**NSLPP MEETING HELD ON 05/06/24****Attachments:**

ADDRESS/WARD: 40 Brightmore Street, Cremorne**APPLICATION NO:** DA409/22**PROPOSAL:** Demolition of an existing apartment building and construction of a new four (4) storey apartment building with associated parking and landscaping**PLANS REF:**

OWNER: Pankay Pty Ltd**APPLICANT:** ABC Planning Pty Ltd**AUTHOR:** Report of Robin Tse, Senior Assessment Officer**DATE OF REPORT:** 22 May 2024**DATE LODGED:** 3 January 2023**DATE AMENDED:** 9 November 2023**RECOMMENDATION:** Approval (Deferred Commencement)

Figure 11: Building height blanket diagram

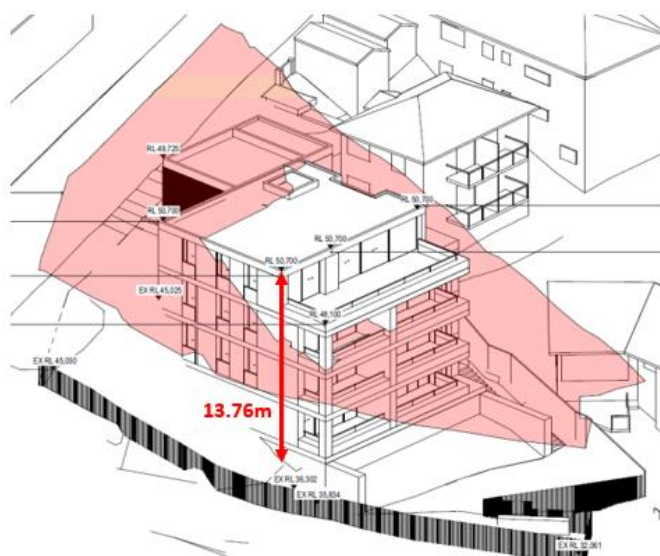
The existing apartment building has a maximum height of 13.82m and breaches the LEP's 8.5 m maximum building height limit for the subject site by 5.32m (62%). The proposed apartment building would reach a maximum height of 13.76 m resulting a breach of the LEP maximum height limit by 4.86m and as illustrated in the building height blanket diagram below (**Figure 11**).

The applicant has submitted a written request to justify the proposed variation to the building height control. The proposed breach has been assessed in accordance with the requirements of Clause 4.6 (3) and (4), the objectives of the control and the zone. These matters have been considered below:

Figure 12: Shadow Diagrams (Mid winter)

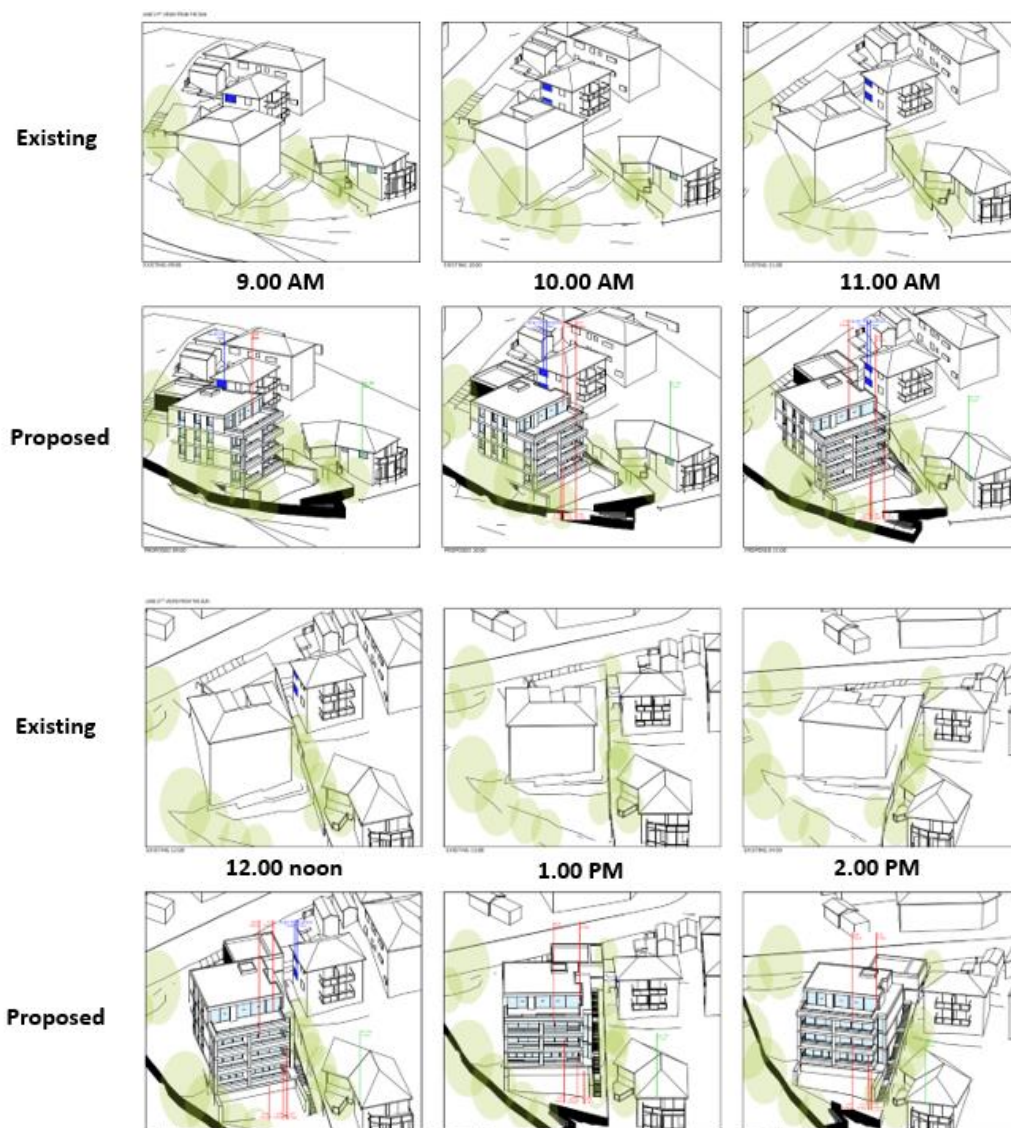
An examination of the submitted sun eye shadow diagram has revealed that solar access to the windows on the eastern elevation of No.38 Brightmore Street would generally be maintained during mid-winter (**Figure 12**). Therefore, the proposed variation to the LEP maximum building height limit would have no material shadowing impacts onto the adjoining/nearby properties.

Figure 13: Proposed design modifications

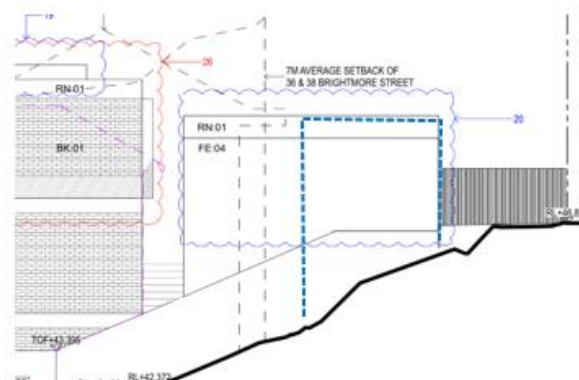
It is recommended that the design of the garbage bin/bulky waste storage enclosure be modified as follows to minimise the bulk and scale of the structure:

- (a) The length of the garbage bin/bulky waste storage enclosure be reduced to 4m;
- (b) The maximum building height of the garbage bin/bulky waste storage enclosure shall be 2.7m maximum as measured from the floor level; and
- (c) The western wall of the garbage bin/bulky waste storage enclosure be setback from the western property boundary by 500mm.

The proposed design modifications would result in a smaller building that would improve the transition of building bulk and scale between the subject site and the adjoining property to the west of the subject site, particularly No. 38 Brightmore Street (**Condition AA1**).

- (c) The design of garbage bin storage and bulky waste storage enclosures, located to the west of the proposed mechanical car stacker facility be modified to provide an integrated waste materials store room;
- (d) The western wall of this modified structure shall provide a minimum 500mm setback from the western property boundary;
- (e) The external length of this modified structure shall not exceed 4m maximum as measured from the southern (front) building line; and
- (f) The maximum height of this modified structure shall not exceed RL 49.50.
